# UNITED STATES PATENT AND TRADEMARK OFFICE

APPLICATION NO.	FILING DATE	FIRST NAMED INVENTOR	ATTORNEY DOCKET NO.	CONFIRMATION NO.
10/786,424	02/25/2004	Kenneth S. Collins	306 D13	2804

## Office Action Summary

## **DETAILED ACTION**

**Fig. 2**

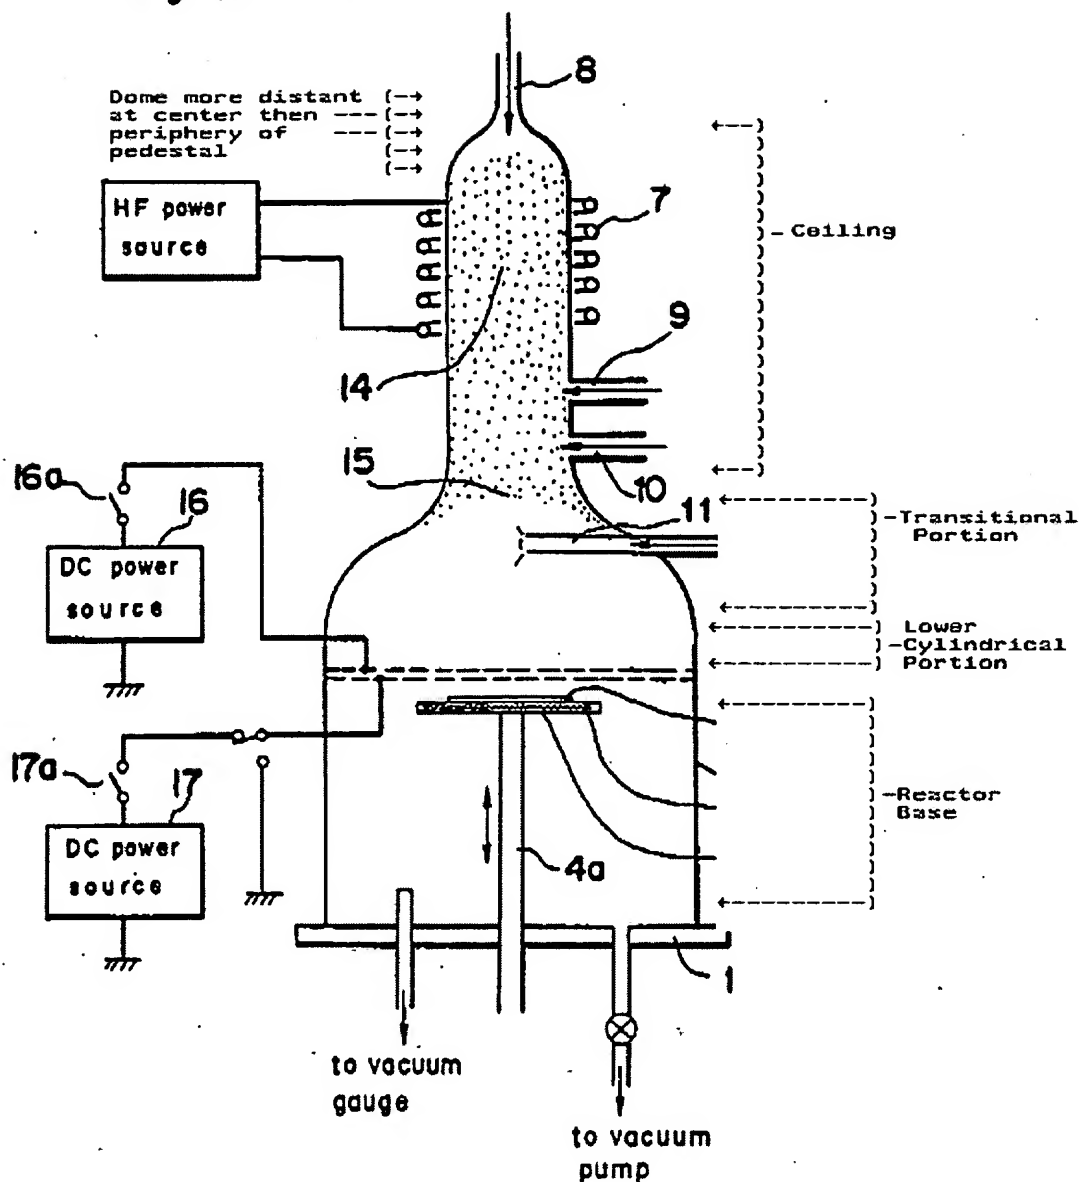
Regarding Claims 1, 2, 10, 11, 22, 23, 25 and 26, Hotomi teach in Fig. 2 a plasma chamber. (See Fig. 2) The plasma chamber includes a pedestal 4, which is adapted to hold a workpiece 3 to be processed. (Column 9 lines 65-68) A reactor base including base plate 1 houses the pedestal. (Column 9 lines 60-61; the reactor base includes the area between the grid and the base plate 1.) A high-frequency coil 7 is arranged adjacent the reactor and inductively couples power into the reactor. (Column 10 lines 11-17) The plasma chamber enclosure structure includes a bell jar 2. (Column 10 lines 60-64) The bell jar 2 is single walled. (See Fig. 2) The enclosure structure is inverted cup shape in configuration. (See Fig. 2) The plasma chamber structure includes a ceiling. (See Figure 2) The plasma chamber enclosure has a central gas inlet 8. (Column 10 lines 18-19) The plasma structure has a sidewall. (Fig. 2) The plasma enclosure has a lower cylindrical portion generally transverse to the pedestal. (Fig. 2) There is a transitional portion between the lower cylindrical portion and the ceiling. The transitional portion extends inwardly from the lower cylindrical portion and comprises a radius of curvature. (See Fig. 2) See Annotated Figure below.

The plasma chamber enclosure structure covers the base. (See Figure 2) A plasma processing volume is 14, 15 defines a plasma-processing volume over the pedestal. (Column 11 lines 68; Column 12 lines 1-5) The plasma chamber enclosure is capable of transmitting inductive power through the enclosure from an antenna. (Column 10 lines 12-17)

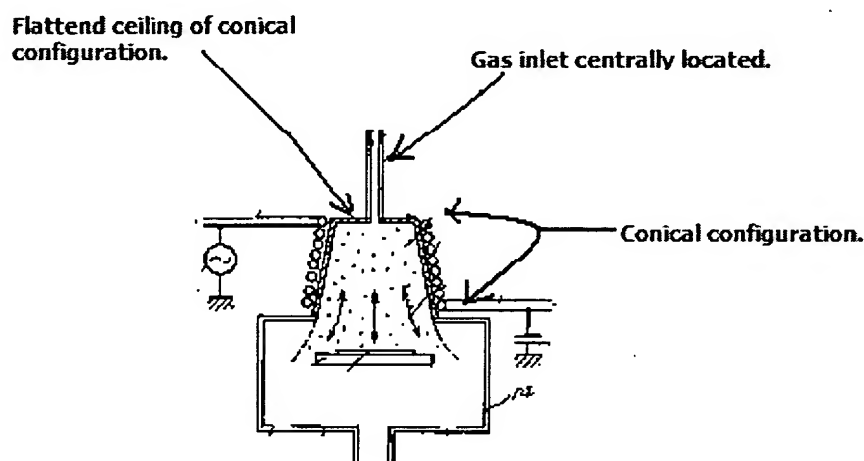
Applicant has removed the terminology of "transitional" and "transition" to try to overcome the Examiner's objection to the drawings. However the Examiner maintains that the portion connecting the lower cylindrical portion and the ceiling extending inward from the cylindrical portion where the portion extends inward having a radius of curvature is not shown. The Examiner requests that this be shown in the drawings or pointed out in the Drawings. The drawing in Applicant's specification that has a flattened conical configuration is shown in Fig. 4E.
